13 VICTORIA PARADE
3 STOREY BRICK
MIXED USE BUILDING

PROPOSED S4.55(8) MODIFICATIONS LIST:

DRAWING TITLE			PROJECT
FOURTH FLOOR PLAN			VPM
SCALE	STATUS	NUMBER	REVISION
1 : 100	s4.55 (8)	A1.06	A

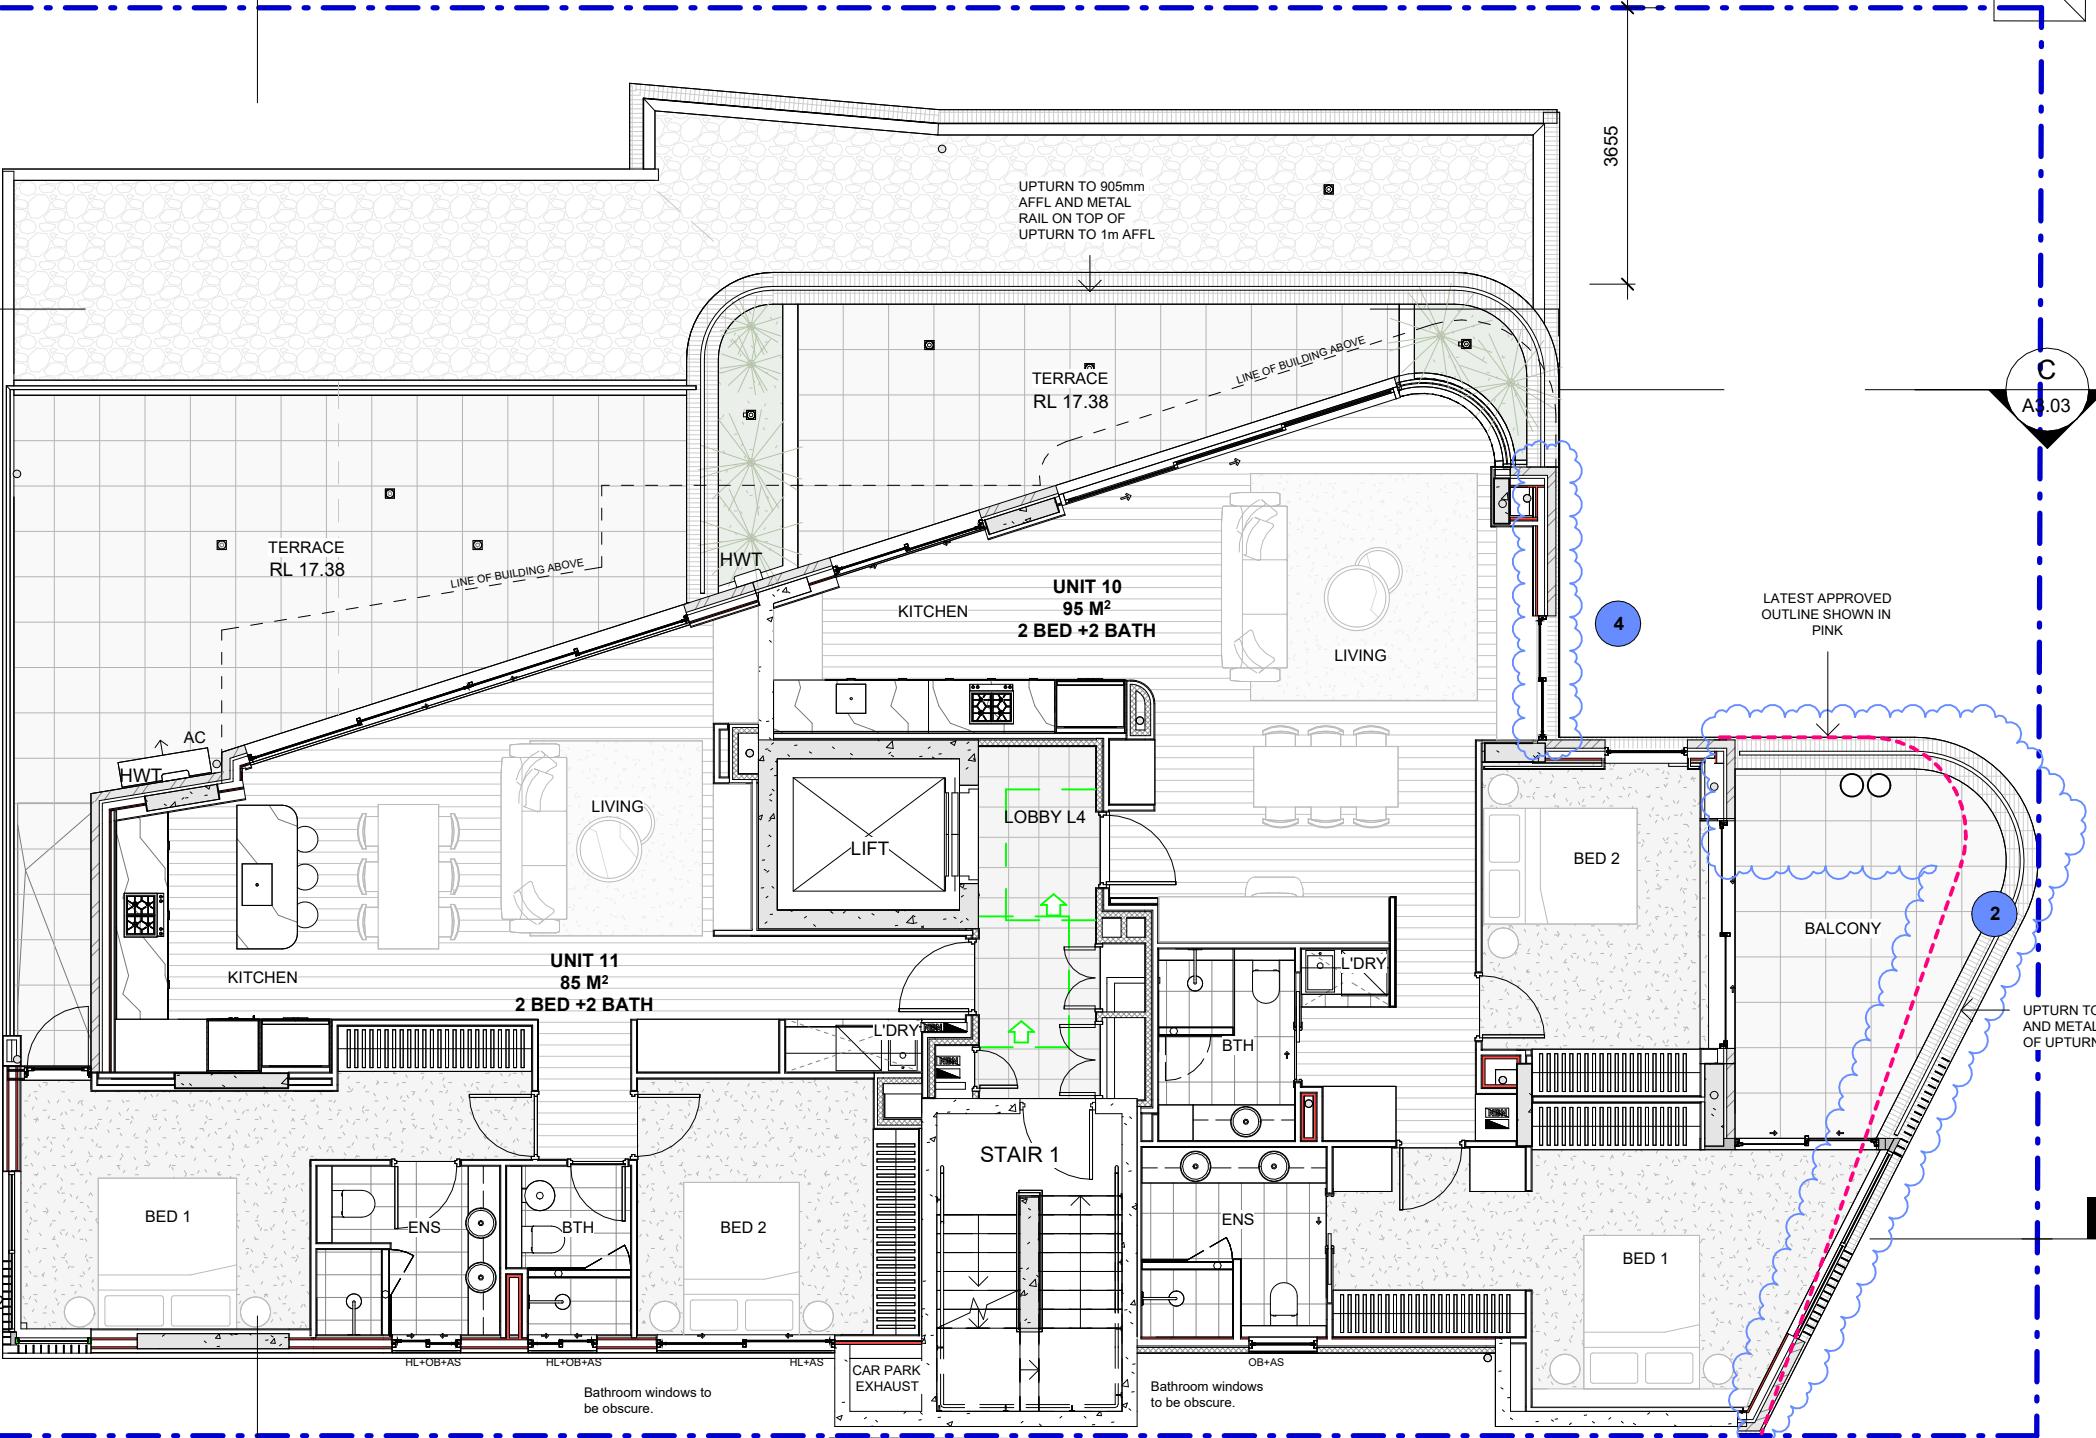
- Retail 1 on Ground floor has been pushed out to enhance the usable area and to suit new columns for balconies above.
- The front facade's angle has been adjusted to enlarge the front balconies and comply with ADG regulations of balcony size.

- Front balconies on level 1 and level 2 were extended to the north east to align with the approved balconies above to avoid looking 'top-heavy' and unbalanced.

- Level 4 brick wall shifted to align with adjacent brick walls.
- Cladding colour proposed to be off-white to visually lighten the bulk of the upper floors.

- Allocation of 1 bicycle space per unit in large storage cages in lieu of separate bicycle parking to satisfy the intention of condition 43D.
- Private roof terrace introduced to improve amenity of unit 14. The glass stair enclosure is not readily visible from the street and has no real impact on privacy, bulk or overshadowing.

- Increase in width of high-light windows to improve ventilation and natural lighting in the bedrooms with no privacy impacts.
- Minor adjustment to the GFA due to the above- still less than LEC approved FSR 3:1.

- Window heads have been lowered to 2.58m to fit services
